RESIDENTIAL ENGINEERING SERVICES, LLC.
SHOP DRAWINGS/SUBMITTAL REVIEW

JOB No.	2595350
DESCRIPTION	SUMMIT HOMES - WOODSIDE RIDGE #20
JOB ADDRESS	2049 NW ASHHURST DR
CITY	LEE'S SUMMIT, MO
DESIGNER	TODD W MOORE
DATE	1/29/2021

ROOF
TRUSS LAYOUT

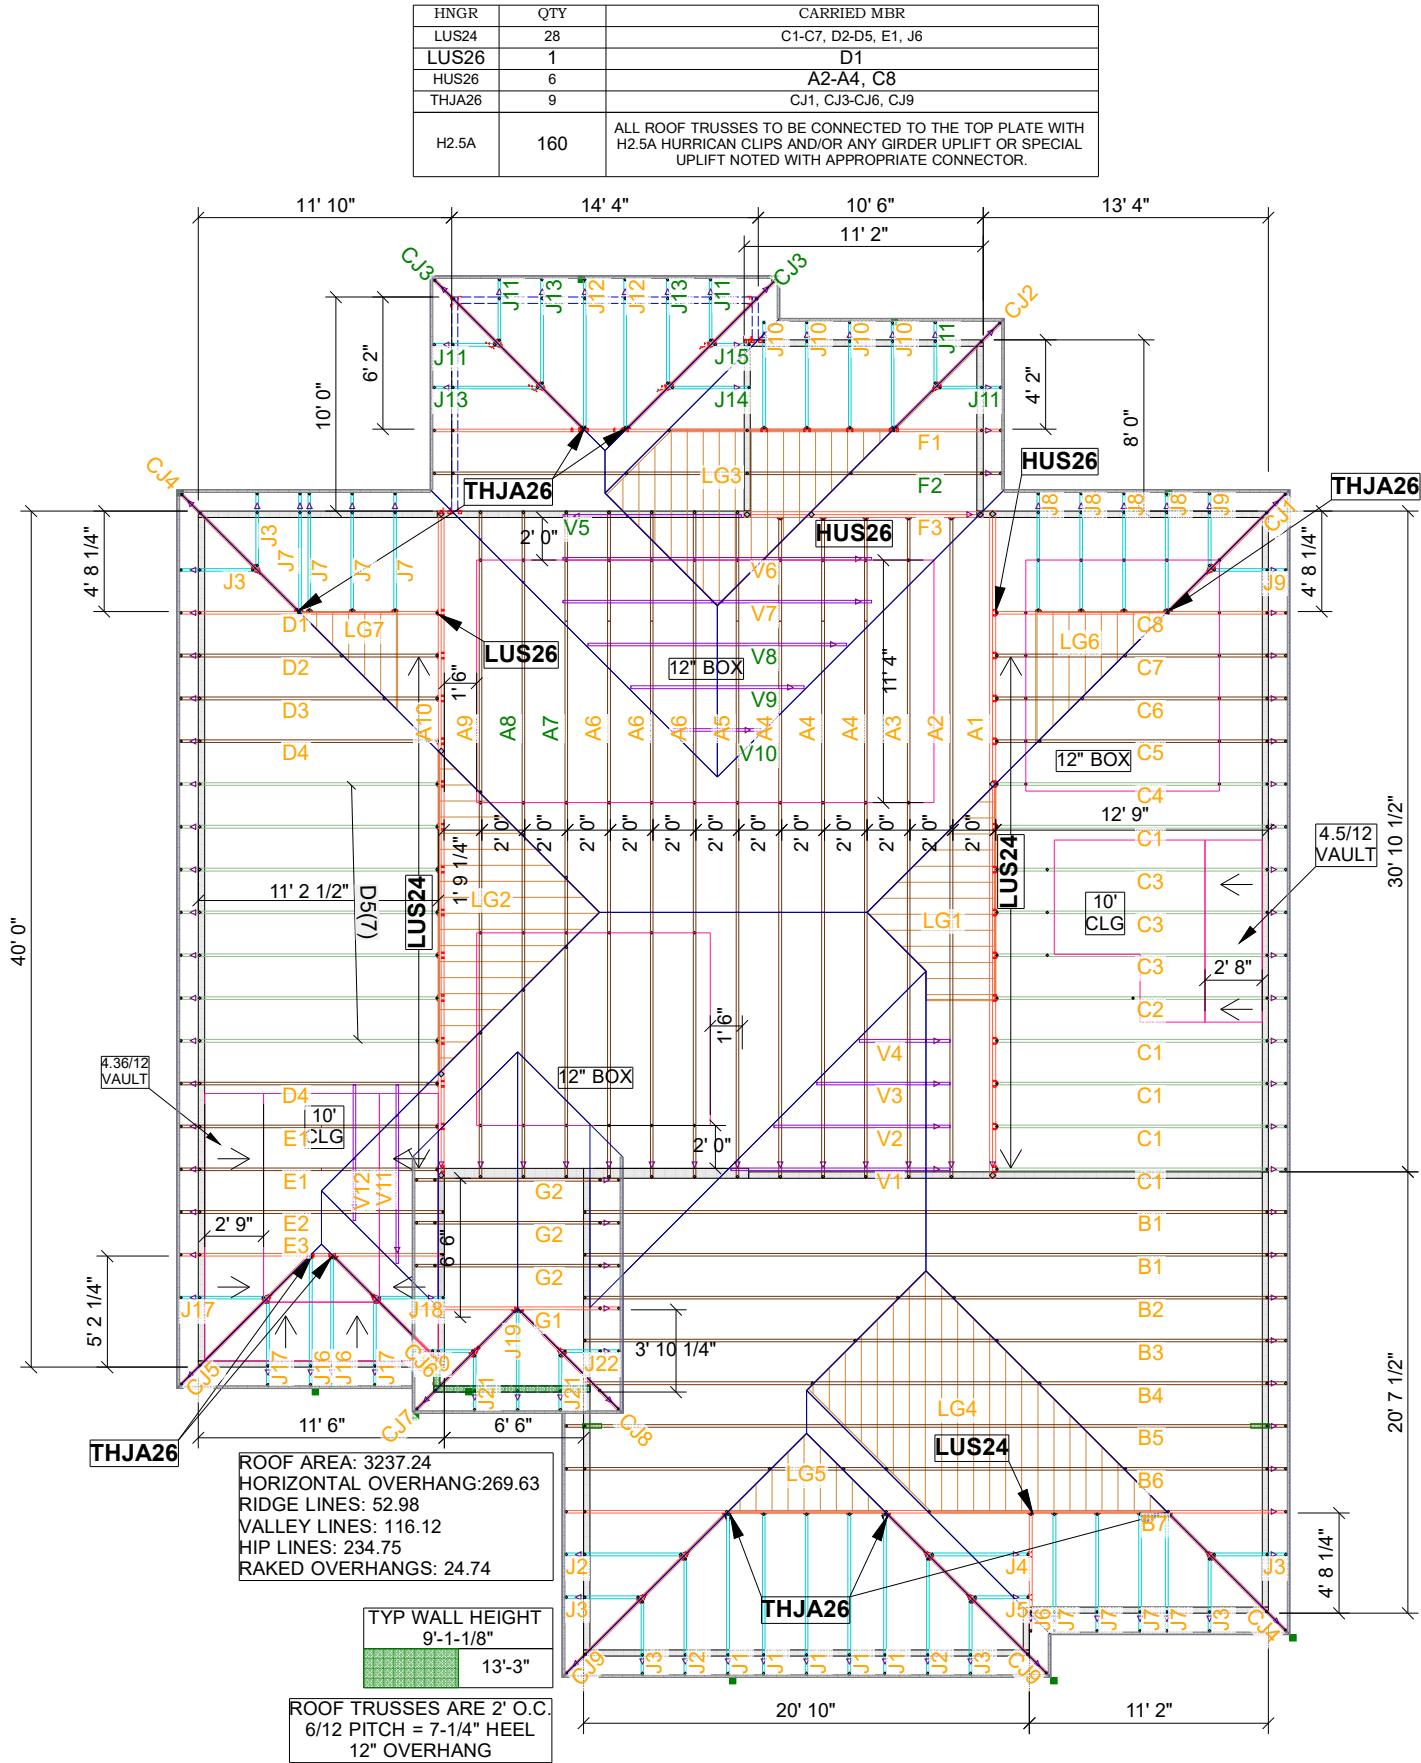
SUBMITTAL WAS REVIEWED FOR DESIGN CONFORMITY AND GENERAL CONFORMANCE TO CONTRACT DOCUMENTS ONLY. THE CONTRACTOR IS RESPONSIBLE FOR CONFIRMING AND CORRELATING DIMENSIONS AT JOBSITE FOR TOLERANCE, CLEARANCE, QUANTITIES, FABRICATION, COORDINATION OF HIS OR HER WORK WITH OTHER TRADES, AND FULL COMPLIANCE WITH CONTRACT DOCUMENTS.

APPROVED
